SUBJECT: GENERIC TECHNICAL ACTIVITIES

TASK ACTION PLAN A-39

SUBJECT: LOADING CRITERIA FOR SUBMERGED STRUCTURES

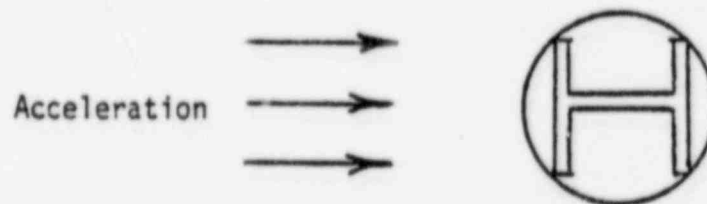
With respect to the development of the drag coefficients for submerged structures, provide the following additional information:

1. A detailed description of the analytical method used to calculate the drag coefficient for all complex structures (i.e., pipe supported by an I-beam).
2. Applicable experimental data.

1. The fluid drag load on submerged structures will consist of two components, standard drag and acceleration drag. Standard drag is the conventional drag due to fluid velocity. Drag coefficients can be obtained from documents such as references 1, 2 and 3. For complex structures such as a pipe supported by an I-beam the drag coefficient is assumed to be between that for a cylinder and a flat plate of the same frontal area. For acceleration drag on simple structures a hydrodynamic volume is used. This is obtained from hydrodynamic mass formulas in reference 4. For complex structures, the acceleration drag volume is based on the area of a circumscribed circle about the target structure along the target length.

2. GE presumes that testing has been performed to establish the published recommendations in the literature for drag coefficients.
